TAMLIN ROAD RV STORAGE

GRADING AND EROSION CONTROL PLANS (W/ POND DETAILS)

PCD FILE NO.: PPR1945

Grading and Erosion Control Plan_v3 redlines.pdf Markup Summary

GRADING AND EROSION CONTROL PLAN

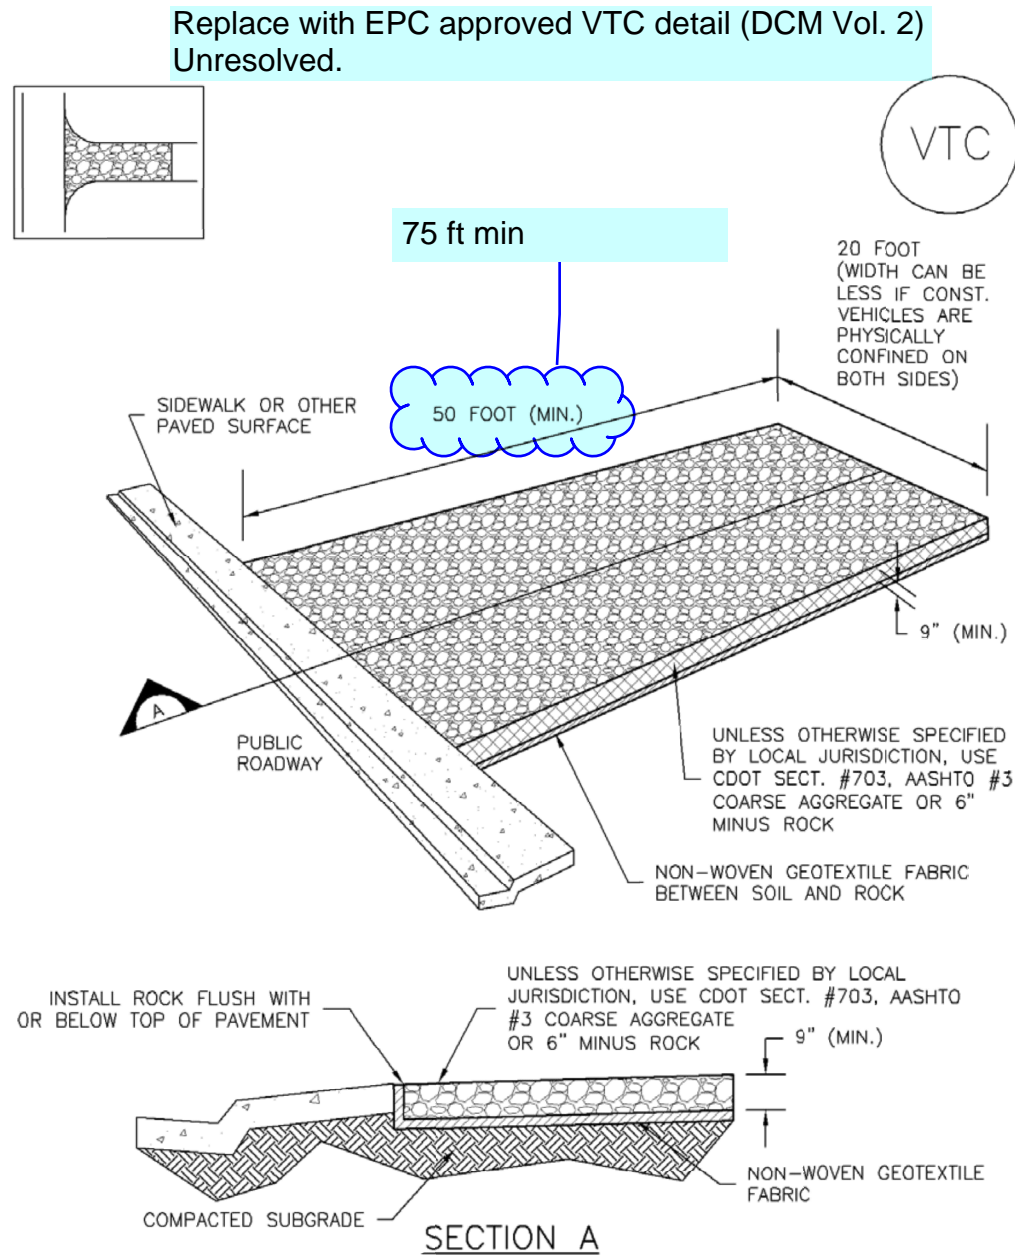
Review 1 comment:
Per DCM Vol. 1 Section 11.3.3, A geotechnical analysis and report with recommendations for the foundation preparation and embankment construction of the detention facilities shall be submitted. Please incorporate any conclusions/recommendations from the soil report in your design.

Review 3: Unresolved. A soil report/geotechnical report with the above information has not been submitted for review.

See comment on the site plan by the PCD project manager and revise as necessary.

Please identify the characteristics (D,W,L, riprap type) of the low tailwater basin required per the flow at this location. A swale is discharging flow into this basin in lieu of a pipe and per the detail provided a pipe size is required to determine the length, width, etc.

GRADING AND EROSION CONTROL DETAILS

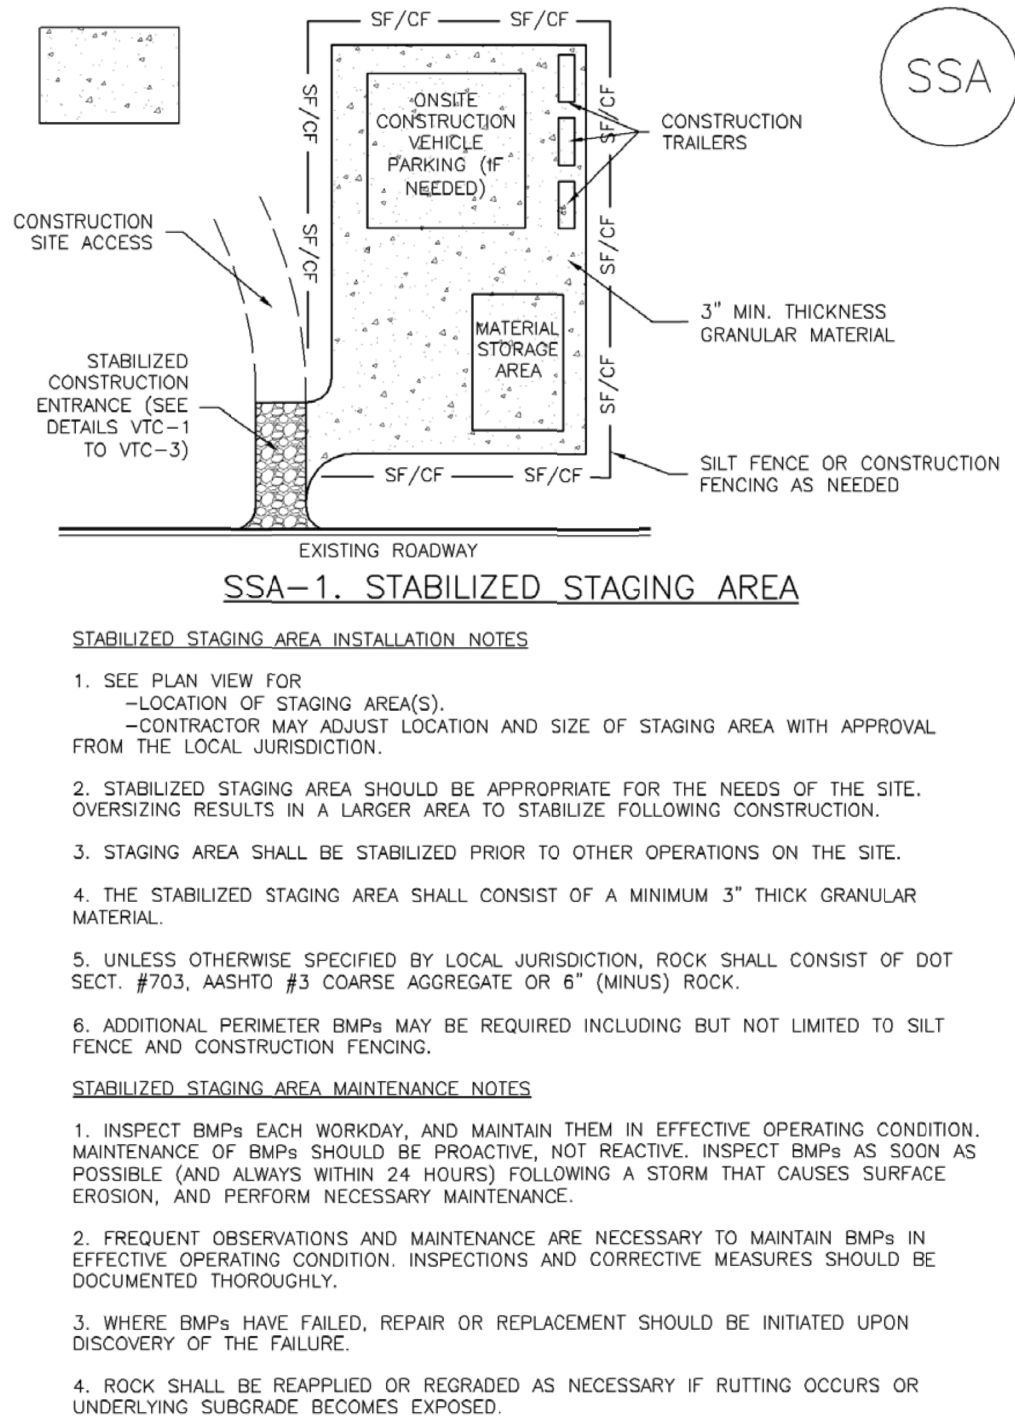
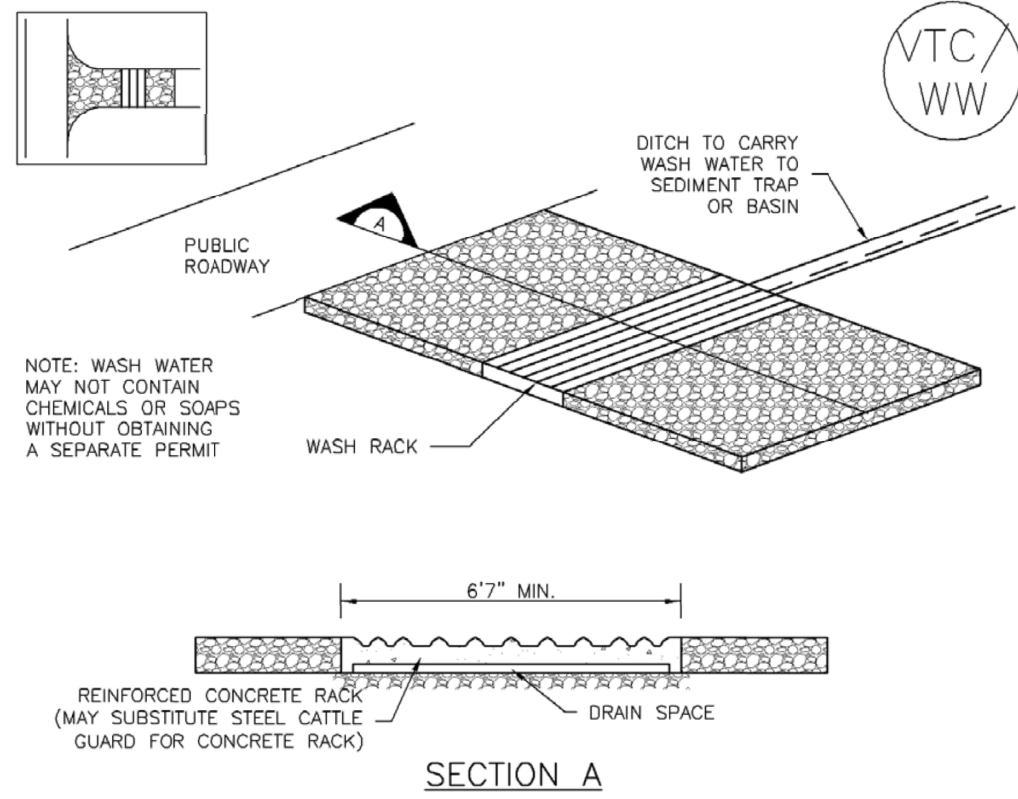
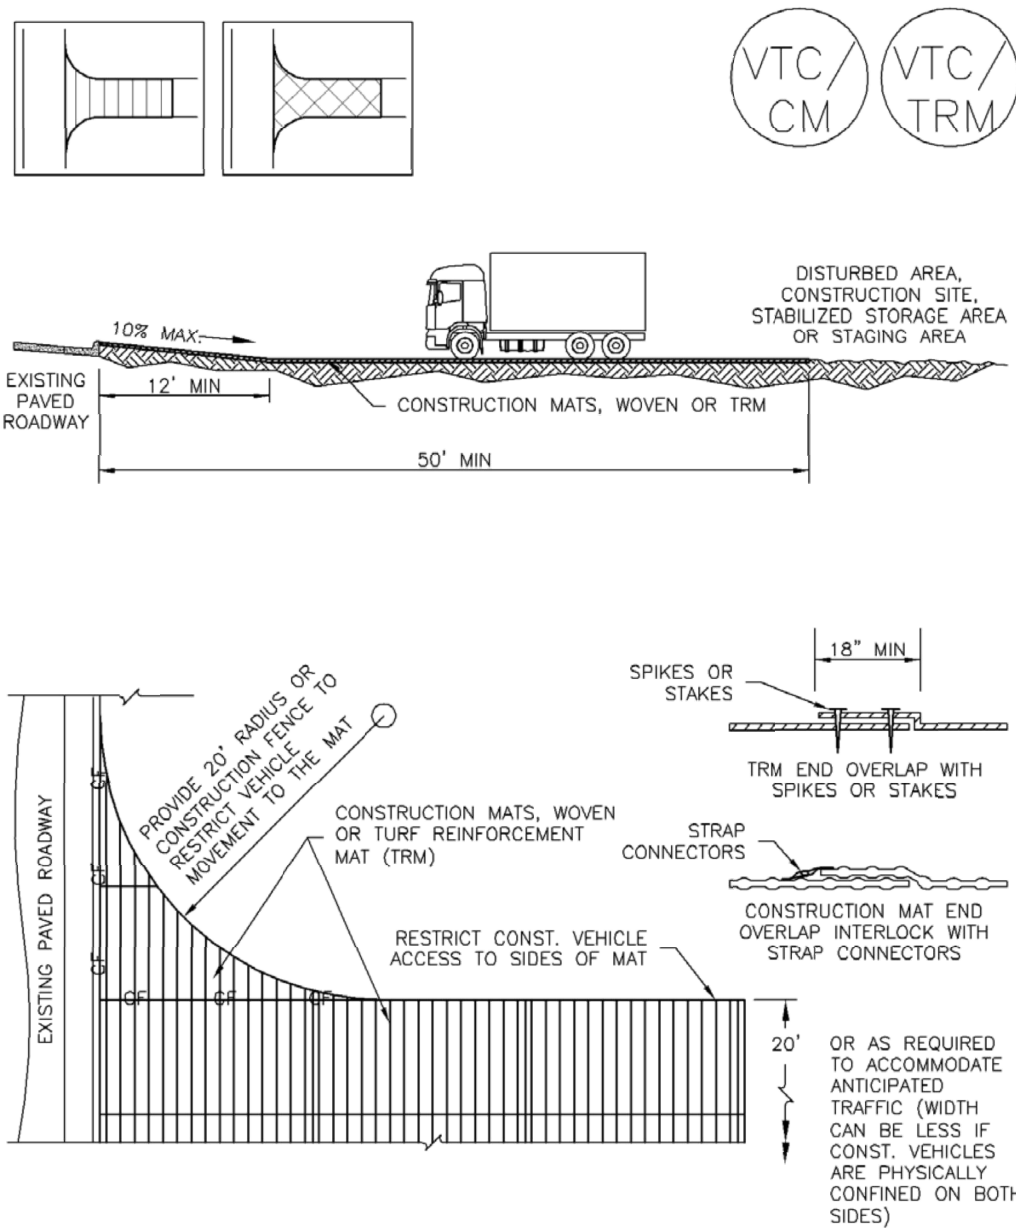
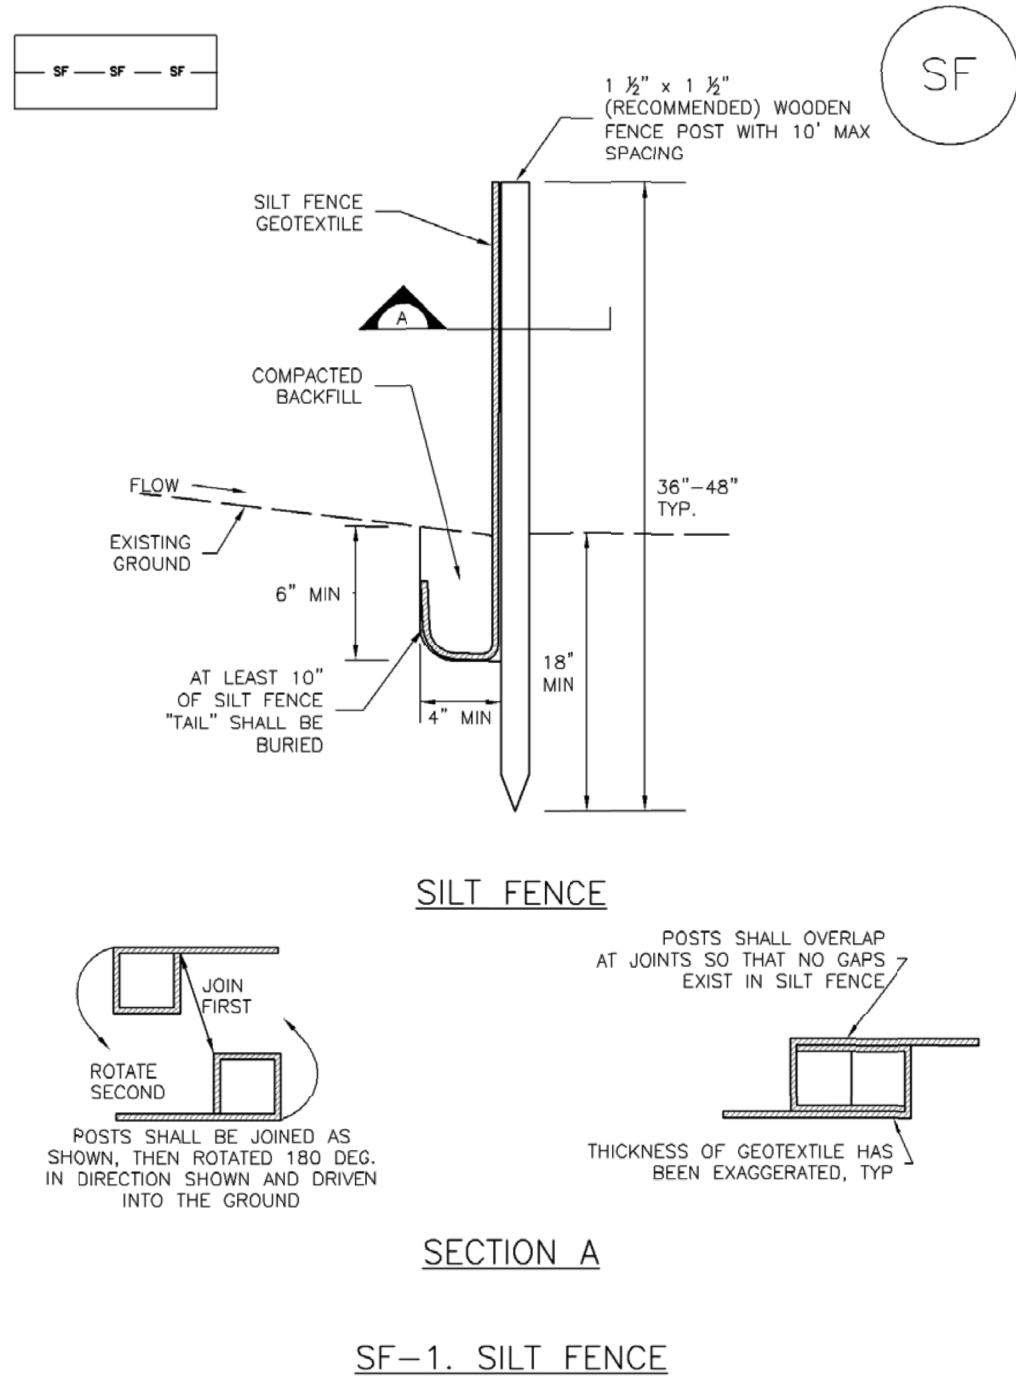
Replace with EPC approved VTC detail (DCM Vol. 2)
Unresolved.

75 ft min
